**Re: Addendum #1 for ITB 21369 – A.J. Rickoff – Life Skills Academy – Range and Hood Installation**

This Addendum #1 reflects the following:

ANDREW J. RICKOFF SCHOOL

LIFE SKILLS ACADEMY

ELECTRICAL FLOOR PLANS

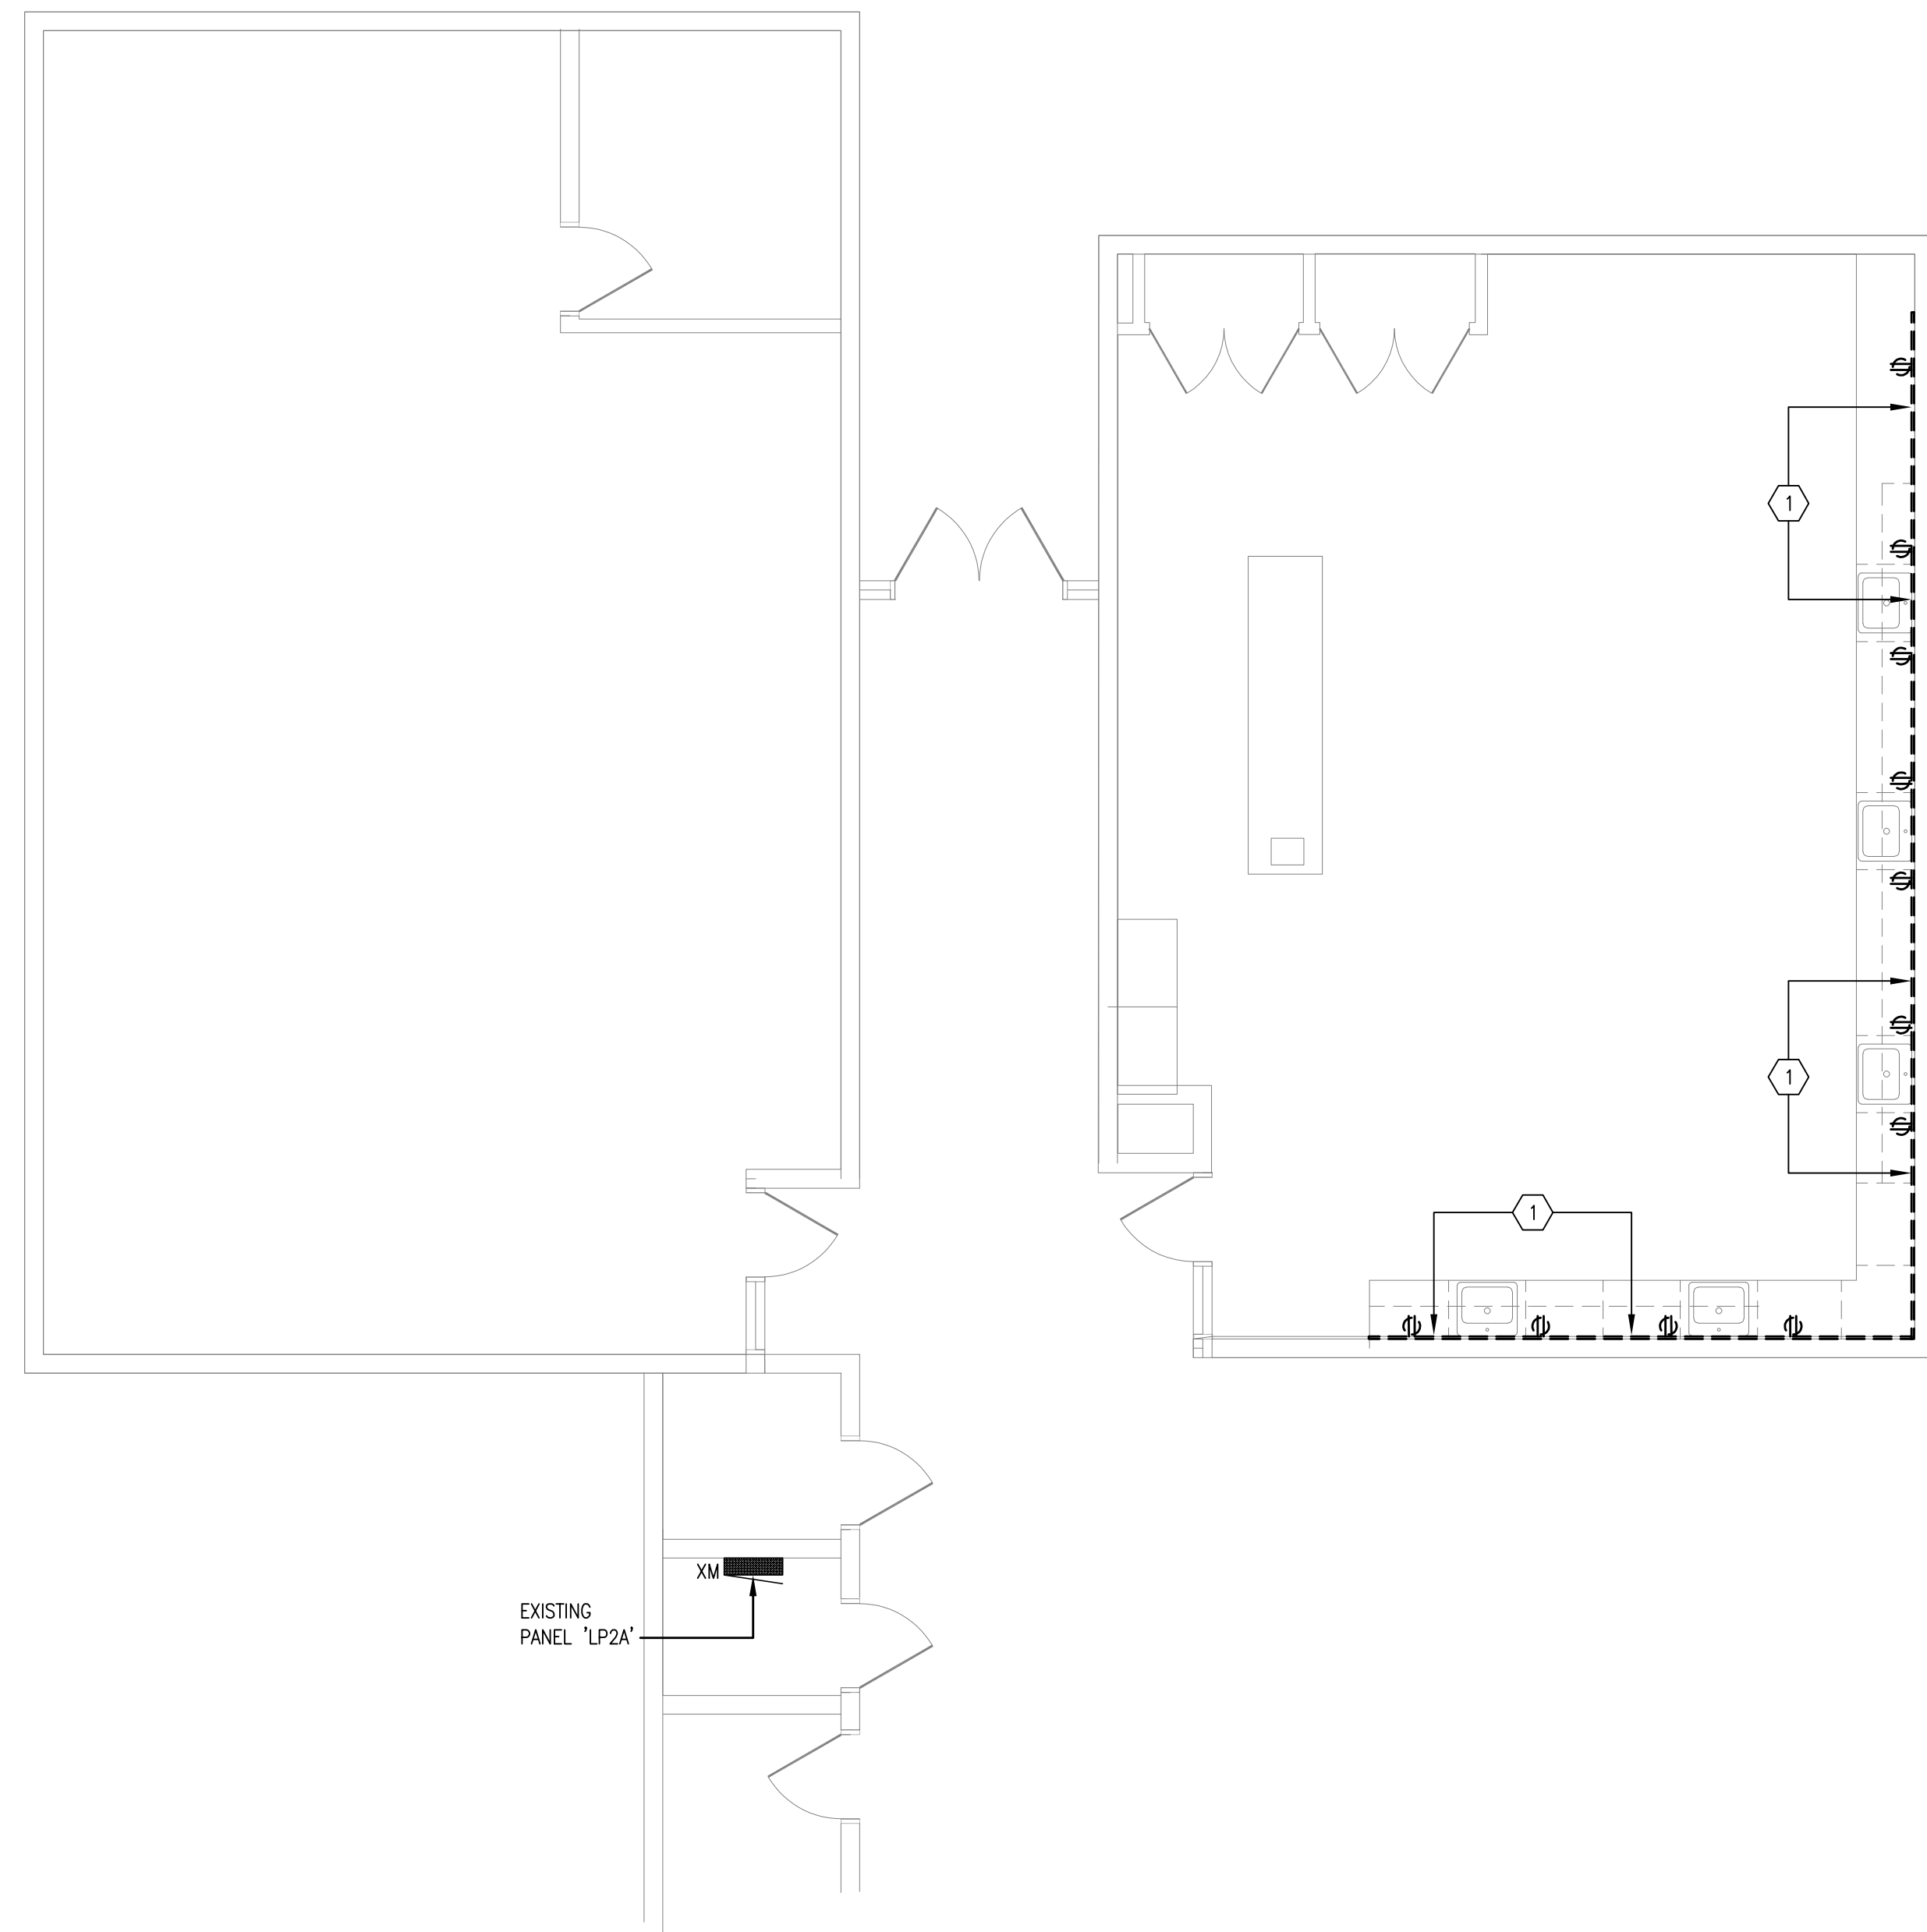
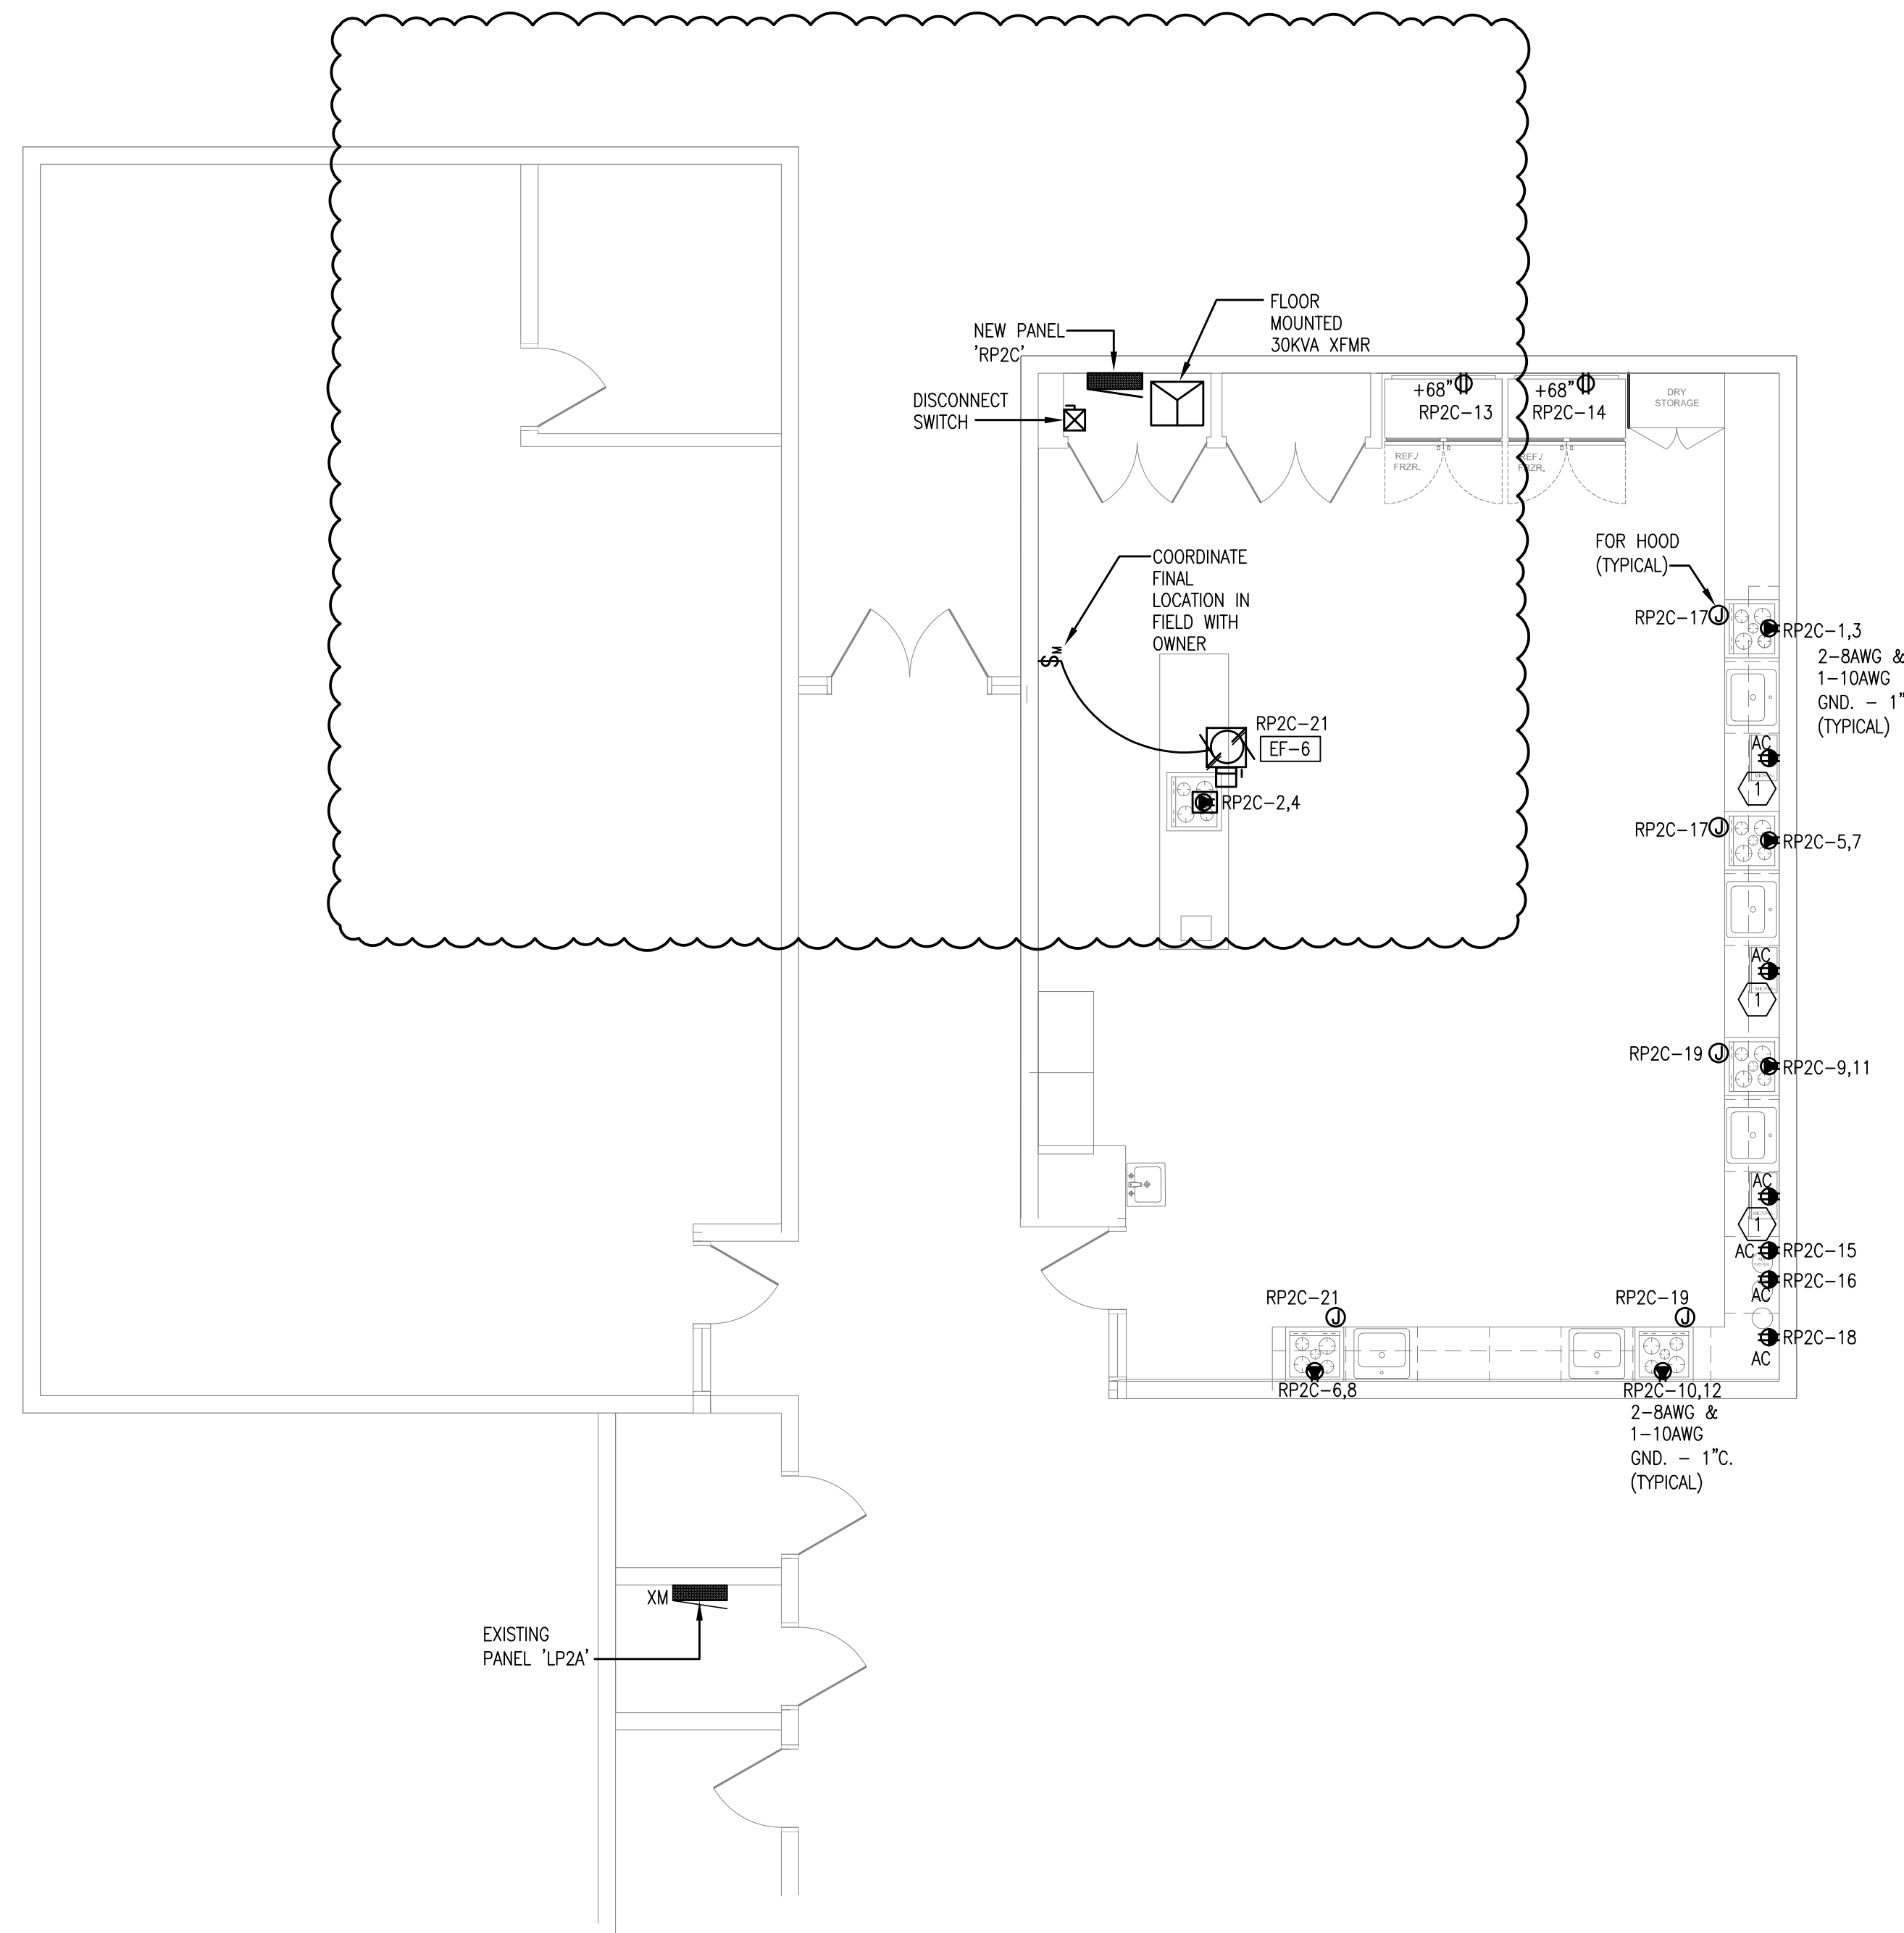
7. Please provide the location of the new location of the new electrical panel "RP2C", transformer, and disconnect. On drawing E1.1, it indicates the new electrical equipment being across the hallway from the life skills classroom. We found this space to be office spaces and seems to be strange place to install an electrical equipment?

See attached.
